Package dimension

Detailed dimension for outer-lead (QFP44-P-1010-0.80A >> LQFP44-P-1010-0.80B)

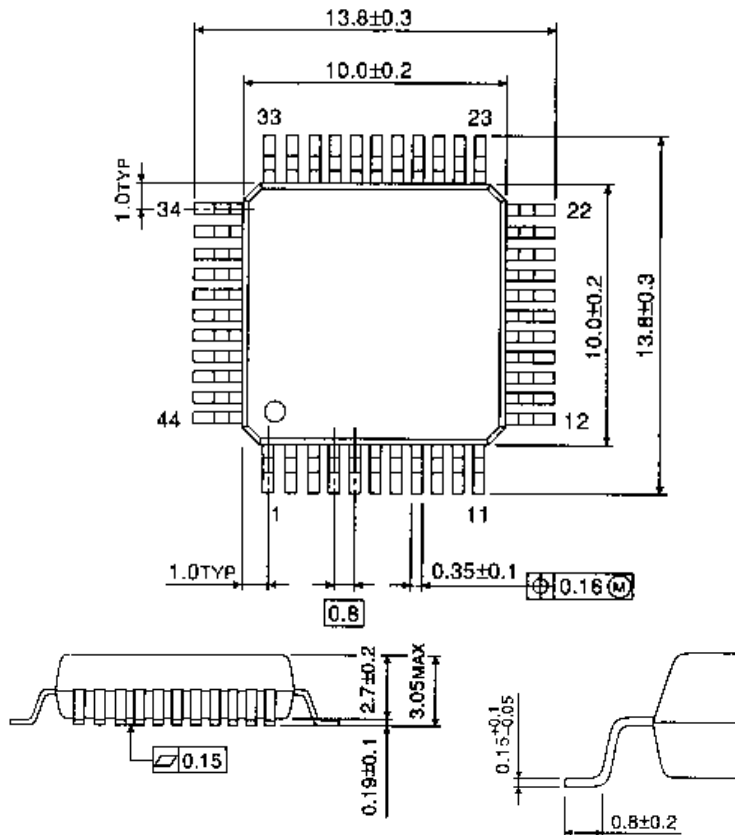
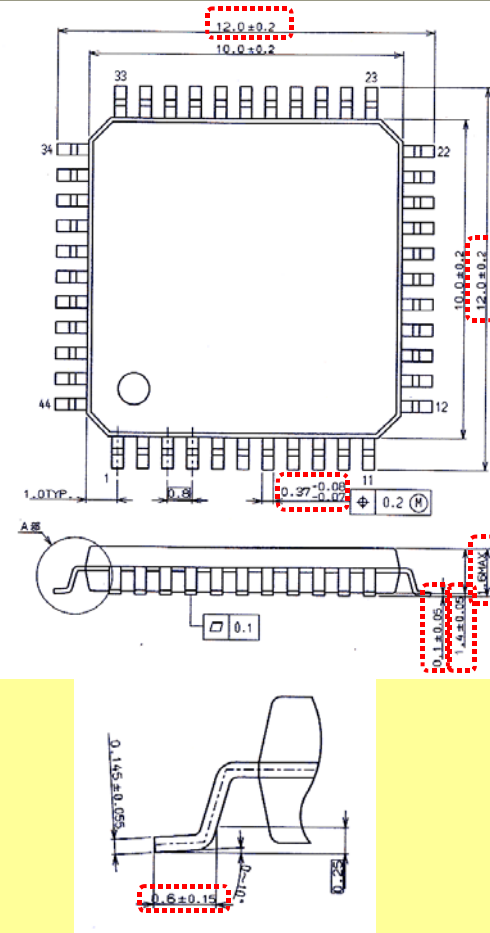
Change point; length(x/y), package thickness, stand off, outer-lead dimension

LQFP44-P-1010-0.80B
